STAFF RECOMMENDATION

1411 Boscobel Street

January 15, 2020

Description of Project: Application is to revise a previously-approved design for duplex infill on the lot.

SITE PLAN
 HPR LOT 172 BLK Q
 LINDSLEY HOME
 1411 BOSCOBEL ST
 NASHVILLE, TN 37206
 PREPARED FOR: MIKE MATHEWS

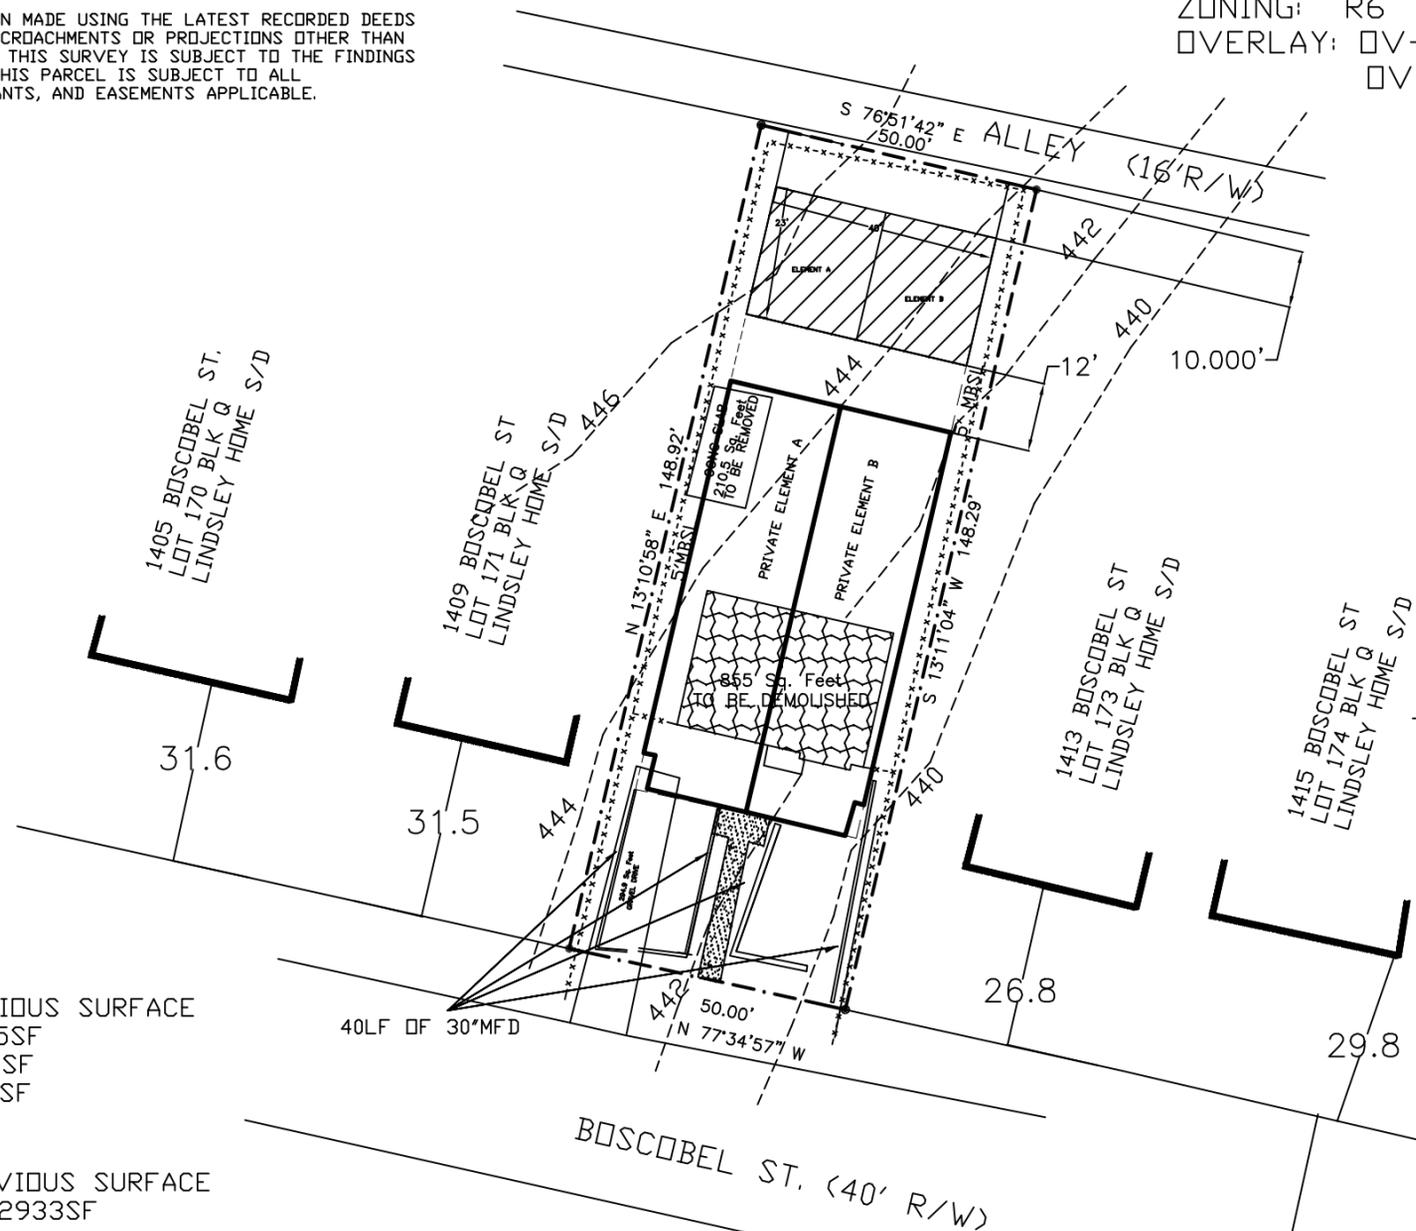
Setback & Rhythm of Spacing: The proposed infill meets all base zoning setbacks. It will be five feet (5’) from the side property lines and approximately forty-four (44’) from the rear property line. The front setback will be the average of the two adjacent setbacks.

Appurtenances & Utilities: The location of the HVAC and other utilities was also not noted. Staff asks that the HVAC be located on the rear façade, or on a side façade beyond the midpoint of the house. The front yard will include modified French drains. Staff recommends that the existing gravel driveway be removed, as front-yard parking is not a historic characteristic of the neighborhood.

FRONT ELEVATION
SCALE: 1/8"=1'

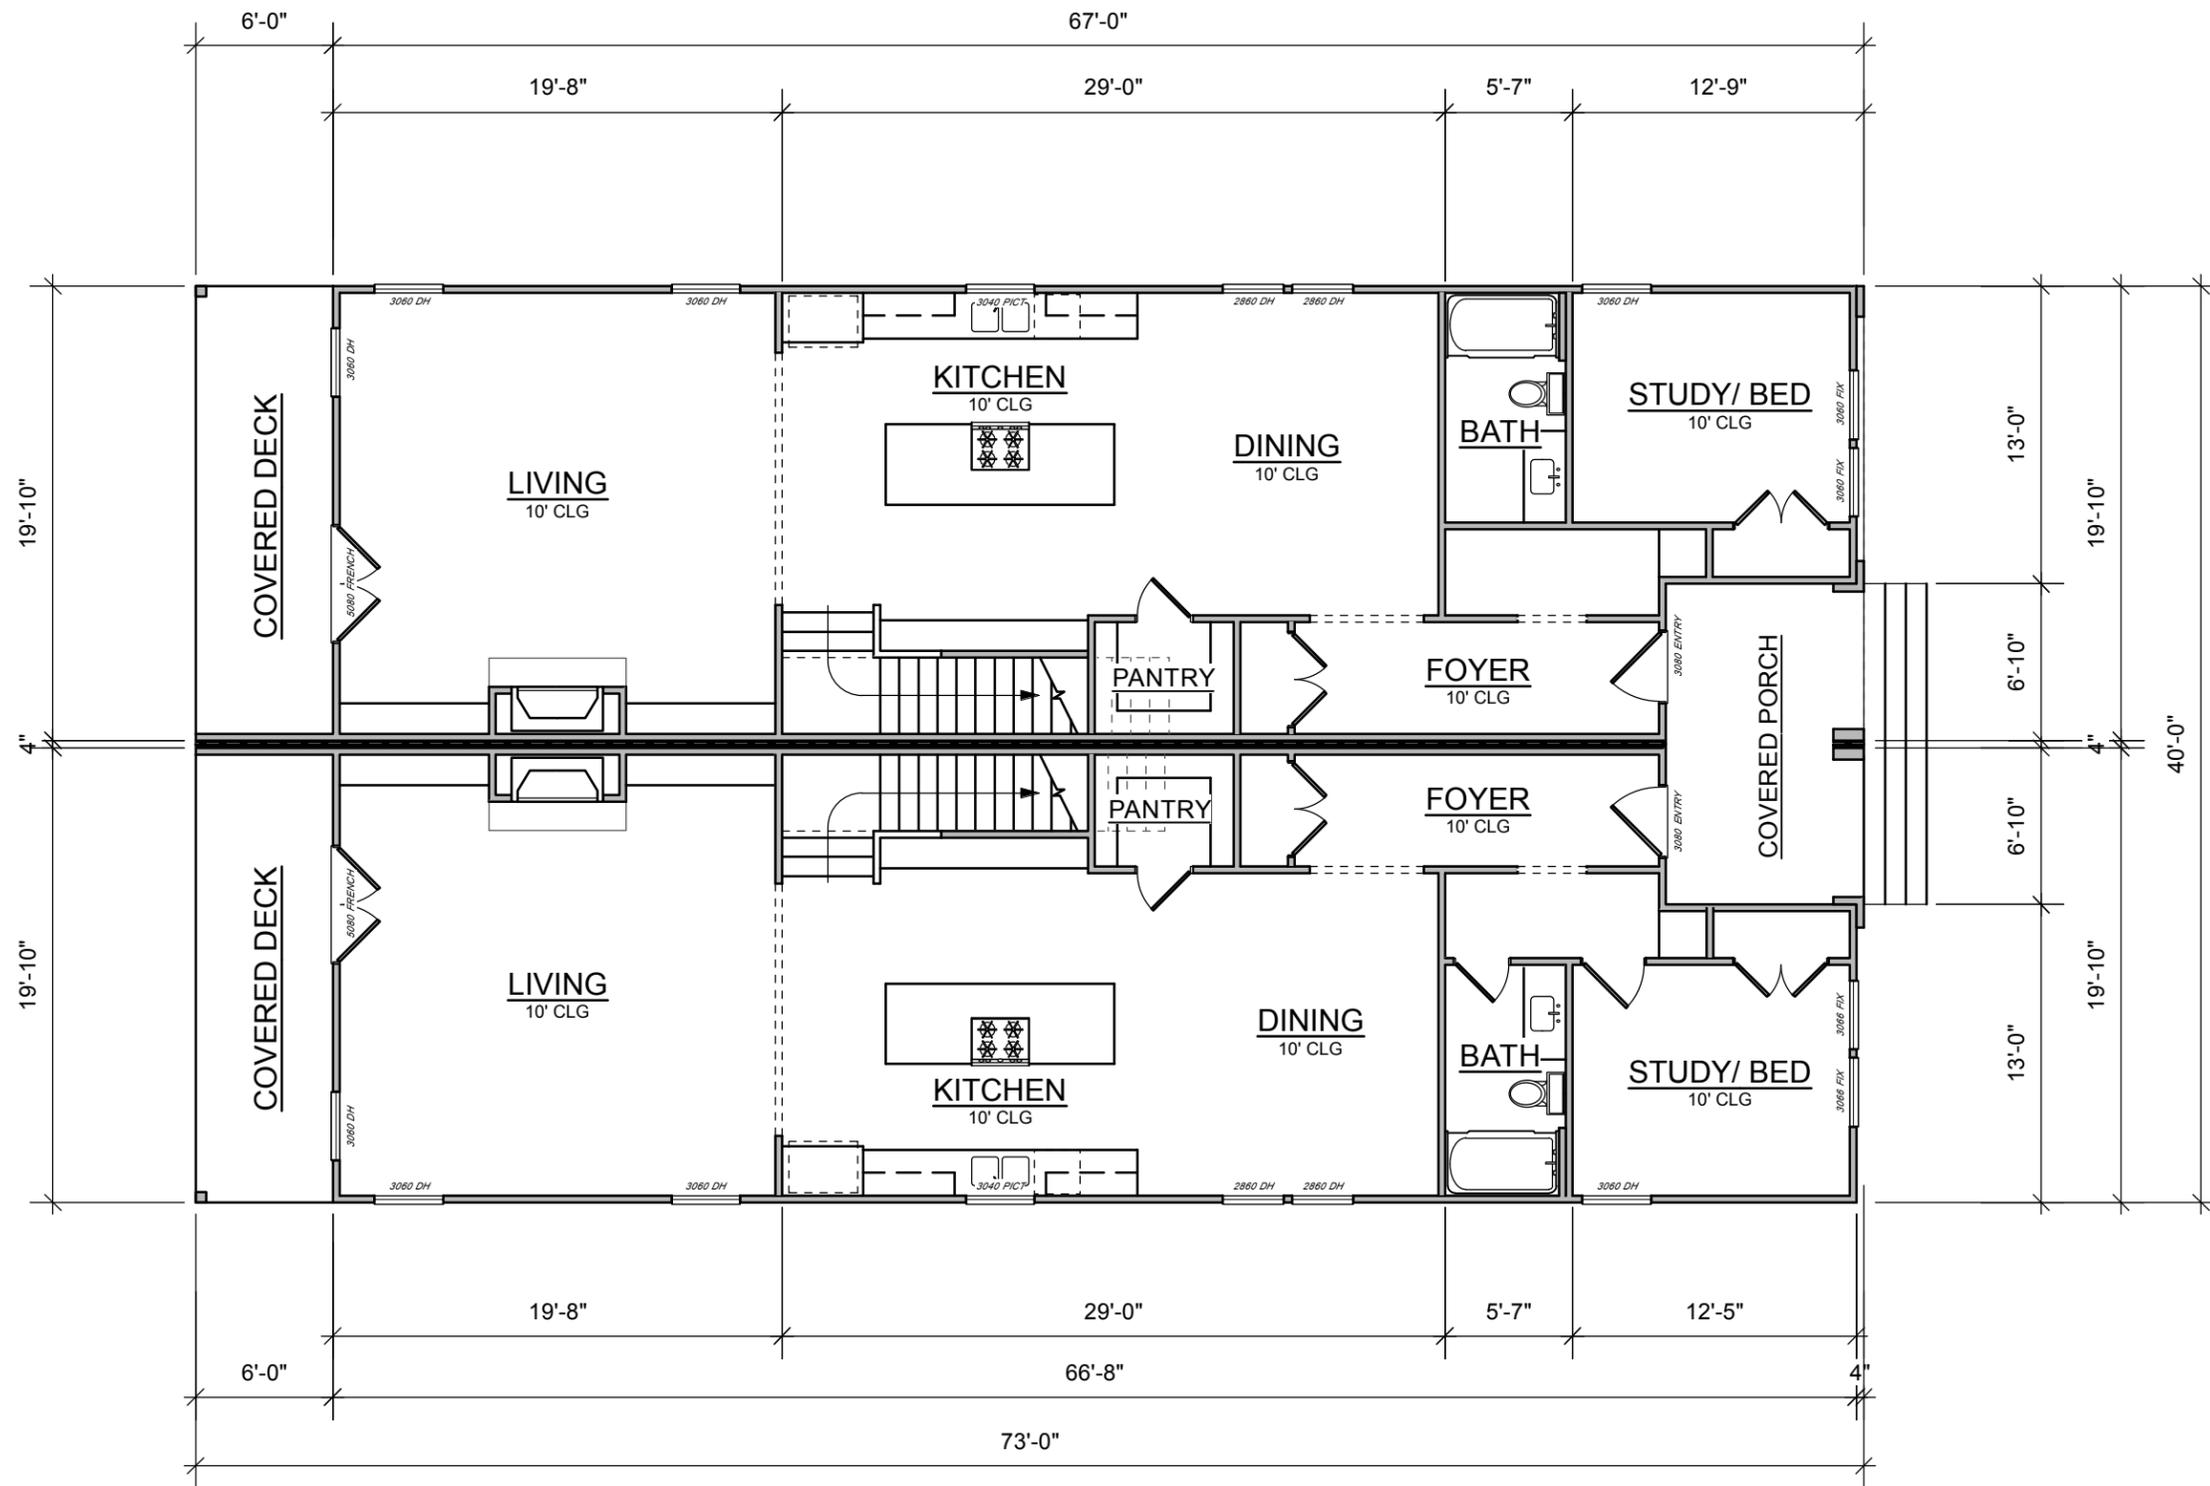
Roof form: The house’s primary roof form will be hipped with a 6/12 slope, which meets the design guidelines. The porch roof will be flat. The front façade contains an uncovered second story deck, which staff finds to be appropriate on this block of Boscobel where there is little historic context. On the rear façade, there will be a rooftop deck that is surrounded by roof on the sides. Staff finds this to be appropriate because it will not be highly visible from the street, it is contained within the roof area, and because this block of Boscobel has little historic context.

Orientation: The new infill will be a duplex, with two front entries facing Boscobel Street. The entries will be located behind a six foot (6’) deep front porch, which is appropriate. The left unit includes a second story balcony over the porch roof. Such a balcony would not be appropriate on many streets on Lockeland Springs but is appropriate on this block of Boscobel where there is little historic context.

Proportion and Rhythm of Openings: The windows on the proposed infill are generally twice as tall as they are wide, thereby meeting the historic proportions of openings. The windows on the ground floor are taller than those on the second story. There are no large expanses of wall space without a window or door opening.

1. The finished floor height be consistent with the finished floor heights of the adjacent historic houses, to be verified by MHZC staff in the field;
2. Staff approve the final details, dimensions and materials of windows and doors prior to purchase and installation;
3. Staff approve the roof color;
4. Staff approve the materials of the front and rear porch floors, stairs, and railings;
5. The existing front gravel driveway be removed; and
6. The HVAC be located behind the house or on either side, beyond the mid-point of the house.
